UNITED STATES PATENT AND TRADEMARK OFFICE

APPLICATION NO.	FILING DATE	FIRST NAMED INVENTOR	ATTORNEY DOCKET NO.	CONFIRMATION NO.
09/970,104	10/03/2001	Motohiro Suzuki	SIW-013	1403
959	7590	11/17/2004		
LAHIVE & COCKFIELD, LLP. 28 STATE STREET BOSTON, MA 02109			EXAMINER ALEJANDRO, RAYMOND	
			ART UNIT 1745	PAPER NUMBER

Office Action Summary	Application No.	Applicant(s)	
	09/970,104	SUZUKI ET AL.	
	Examiner	Art Unit	
	Raymond Alejandro	1745

DETAILED ACTION

FIG. 17

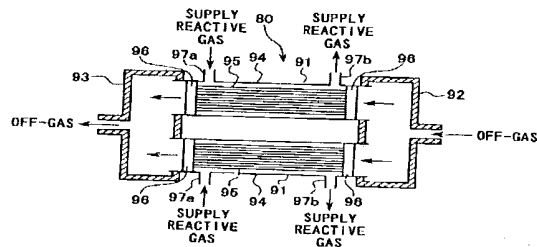
As shown in Figure 17 above, the humidifier has a liquid exhaust mechanism including two supply reactive gas outlets: an upper supply reactive gas outlet 97b and a lower supply reactive gas outlet 97b as indicated by stream flow arrow in Figure 17. Thus, it is noted that the lower supply reactive gas outlet 97b from which humidified supply reactive gas is exhausted is positioned below both the off-gas flow entrance as well as below, at least, an upper supply reactive gas inlet 97a. Thus, the humidifier of Figure 17 satisfies the required functional and structural relationship of the claimed invention.

The APA'104 discloses a humidifier for a fuel cell according to the foregoing aspects. However, the APA'104 does not expressly disclose the liquid exhaust mechanism being separate from the reactive gas exits.

In view of the above, it would have been obvious to one skilled in the art at the time the invention was made to separate the liquid exhaust mechanism from the reactive gas exits/off-gas exits of the APA'104 because it has been held that making a device/feature either integral and/or separable is obvious. Succinctly stated, fact that a claimed device/apparatus/element is made separable, integral or adjustable is not sufficient by itself to patentably distinguish over an otherwise old device unless there are new or unexpected results as it is a matter of choice which a person of ordinary skill in the art would have found obvious absent persuasive evidence that the particular configuration of the claimed humidifier was significant. In re Larson 144 USPQ 347, 349. In re Dulberg 129 USPQ 348, 349. In re Stevens 101 USPQ 284. In re Lindberg 93 USPQ 23. (*See MPEP 2144.04 [R-1] Legal Precedent as Source of Supporting Rationale: V. Making Portable, Integral, Separable, Adjustable, or Continuous*).
